Office Action Summary	Application No. 10/589,317	Applicant(s) MOSER ET AL.	
	Examiner ROBERT E. FULLER	Art Unit 3676

DETAILED ACTION

2. Claims 1-11 are rejected under 35 U.S.C. 102(b) as anticipated by or, in the alternative, under 35 U.S.C. 103(a) as obvious over Dunn et al. (US 6,595,305).

Figure 1 - Dunn et al. as it relates to the claimed invention.

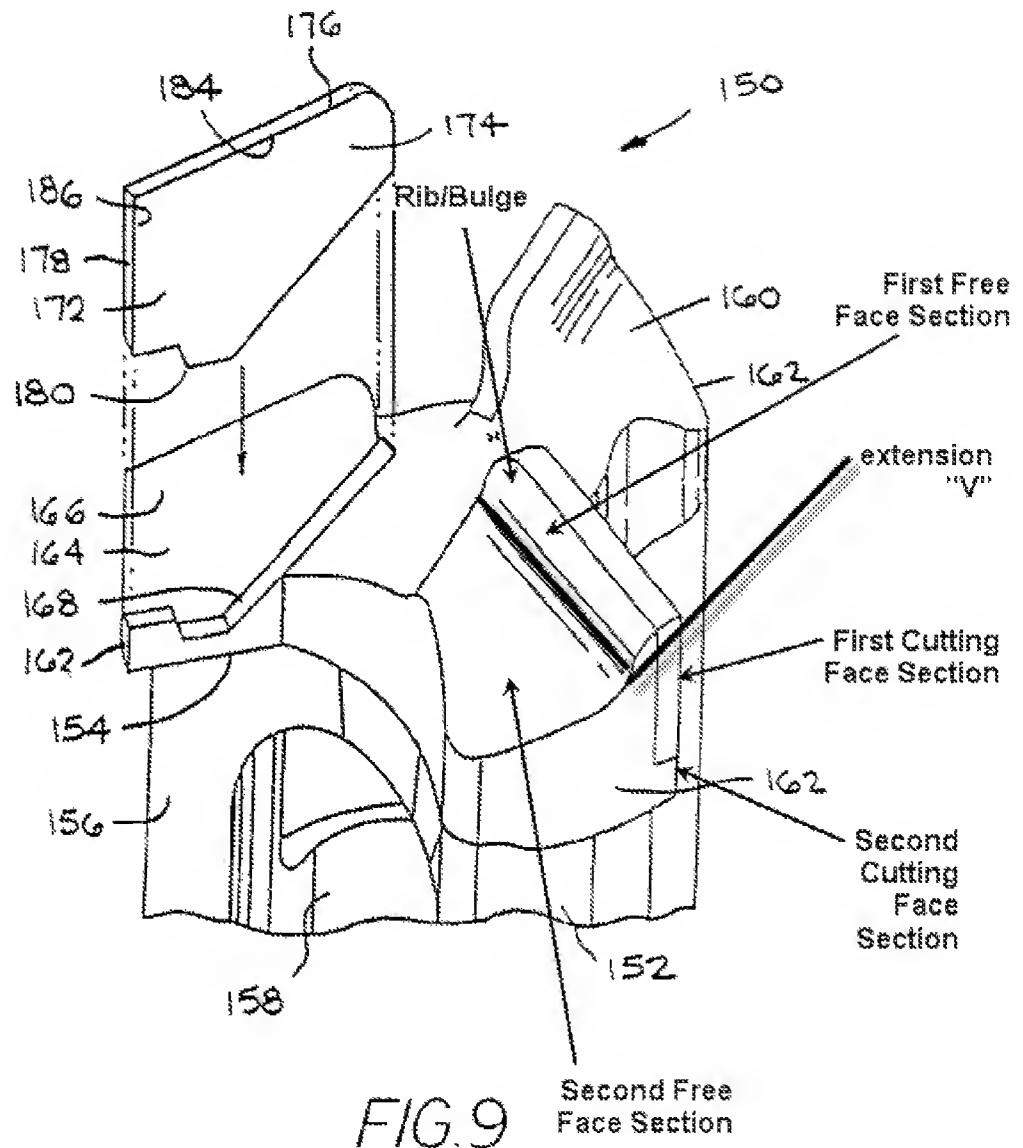
With regard to claim 1, Dunn discloses a drilling tool (150) for percussion drilling, which comprises a cutting element (162) that is configured as a plate or head and that has at least one cutting edge (184) defined by a cutting face (174) and a free face (160), wherein the cutting edge is associated with a first free face section (see Figure 1 below) which lies in a cutting plane, wherein the cutting plane (CP) is cut at a right angle to the cutting edge and wherein the first free face section is limited by a convex bulge (see Figure 1 below) or a convex polygon outline, and a rib (see Figure 1 below).

With regard to claims 5 and 6, Dunn discloses a second free face section and a second cutting face section (see Figure 1 below).

With regard to claim 7, an extension (see “V” in Figure 2 below) of the second free face section extends in a direction of rotation of the drilling tool through the cutting element below the cutting edge.

With regard to claim 9, as discussed above, examiner has arbitrarily assigned where the first free face and second free face sections meet, therefore, claim 9's limitations are met, since Dunn inherently discloses planes P and E, and they are parallel. Note that claim 9 can only read on the embodiment of the invention in which the height of the rib does *not* increase or decrease toward the longitudinal axis, since in those two cases, the planes P and E would not be parallel.
